| NO.       | DESCRIPTION | DATE    | BY |
|-----------|-------------|---------|----|
| 1         | ADDENDUM 2  | 7/10/25 | JB |

**TAXIWAY BRAVO  
RECONFIGURATION  
(HOT SPOT 1)**

**LIGHTING PLAN  
TAXIWAY ALPHA  
STA. 47+25.00 TO  
STA. 53+50.00**

**E-LT-02**

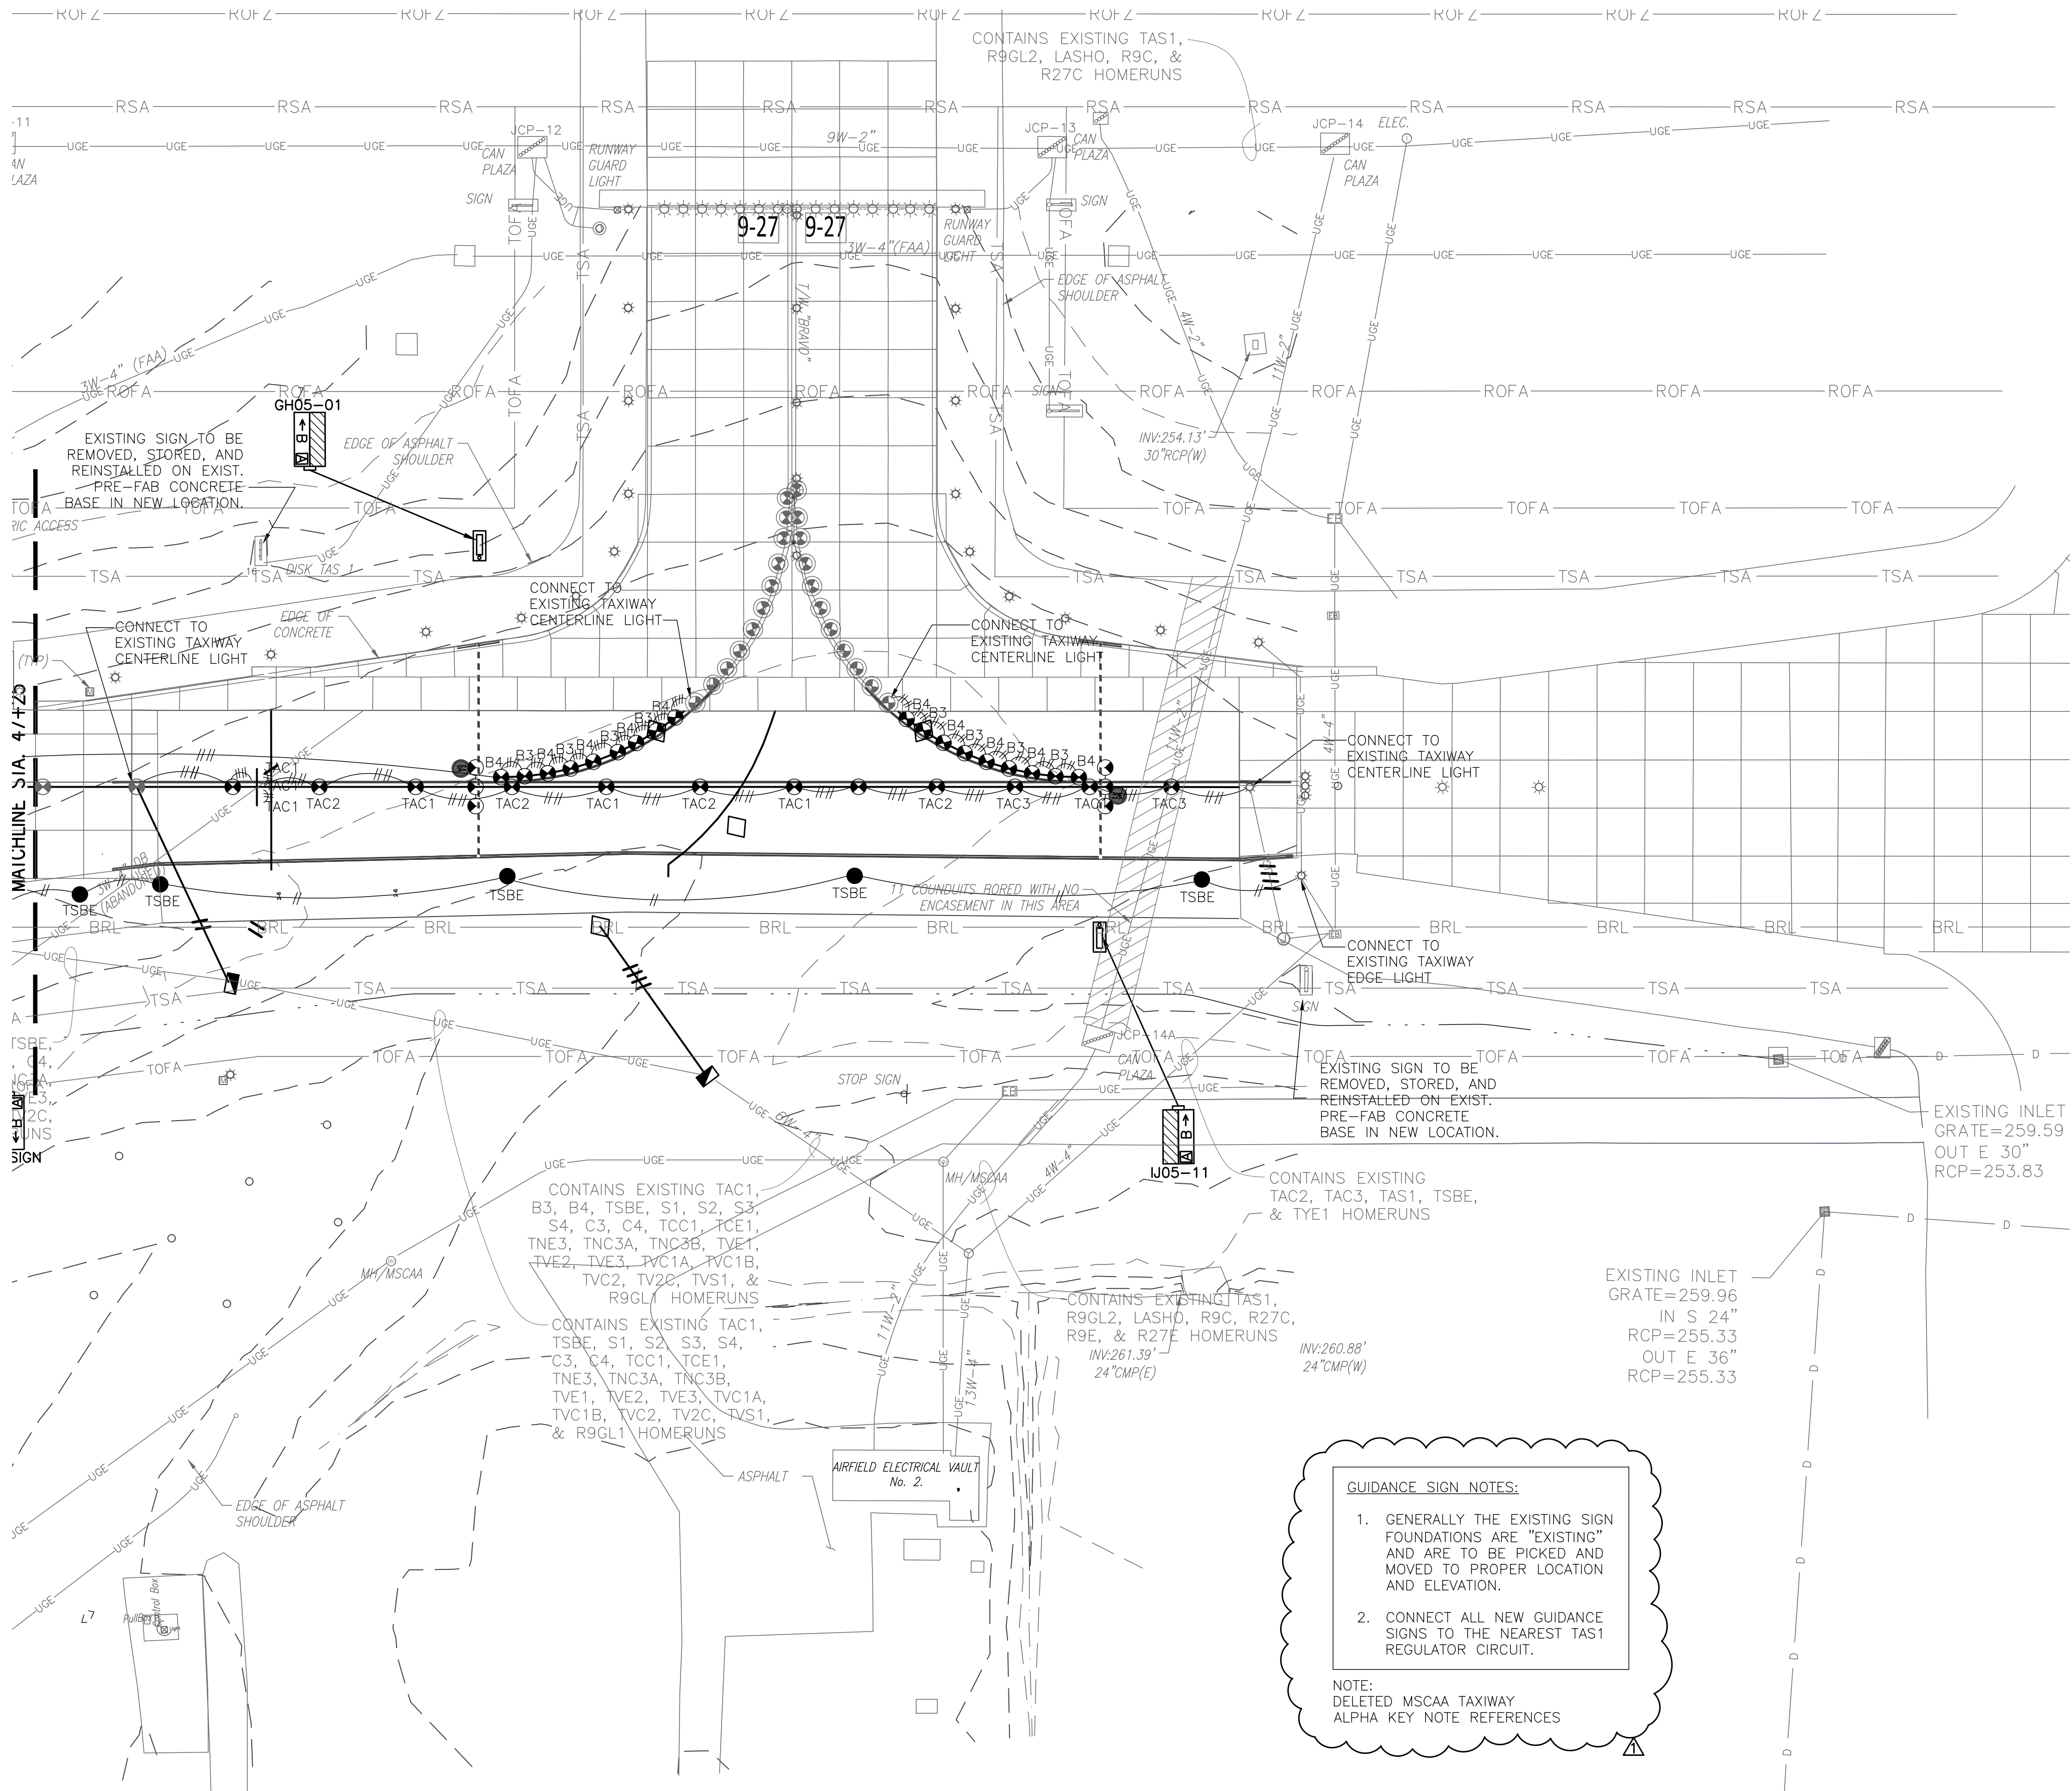
NOTE:  
DELETED MSCAA TAXIWAY  
ALPHA KEY NOTE REFERENCES
